| | COMPO | NENT CODE | 6B |
|-----------------|---------|---------------|----------|
| PARTS & SERVICE | REF NO. | AH03014 | |

SUBJECT: Travel Motor - HST Tube update

PURPOSE: To introduce mounting of an additional bracket between travel motor and HST tubes, to avoid cracks at the welding between flange and tube

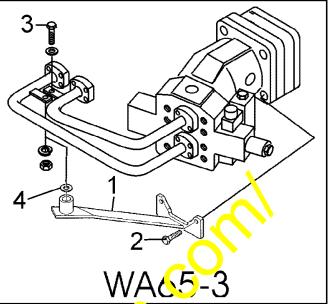
On the Compact Wheel Loaders mentioned above, it can happen that the welding between flange and tube at the HST tube cracks (arrow). To avoid this damage, an eductional bracket is now mounted.

In case of repair (crack of the welding between flange and tube) the HST tube has to be replaced and the additional bracket has to be mounted). On Page 2 you can find the instructions for replacing of the HST tube and mounting of the additional bracket.

- 1. Open the hydraulic tank slowly, to release the hydraulic oil pressure.
- 2. REmove the screw (Pos. 3) from the tube bracket.
- 3. Set a container under the tube and remove the damaged tube.
- 4. Mount the new tube hand-tightened, using new O-rings.

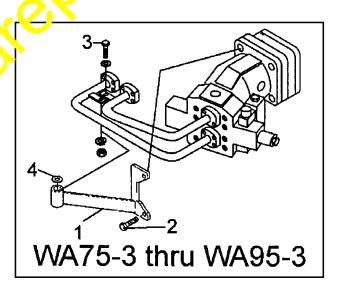
- 5. Remove the 2 screws (Pos. 2) from the travel motor.
- 6. Mount the new bracket (Pos. 1) with the 2 new screws (Pos 2) at the travel motor.
- 7. Mount the other end of the bracket with the new screw (Pos. 3) and the current shims and nut at the brackets of the tubes, using the adjustment shim. (Pos. 4).

NOTE: The bracket has to be mounted vite sufficient clearance.

8. Tighten the new screws. Tightening torques:

WA65-3 and WA75-3:

2 screws (Pos. 2) at travel motore: 115 Mm 1 screw (Pos. 3) at the bracket 70 Nm

WA90-3:

2 screws (Pos. 2) at travely over . 260 Nm; 1 screw (Pos. 3) at the bracket 70 Nm
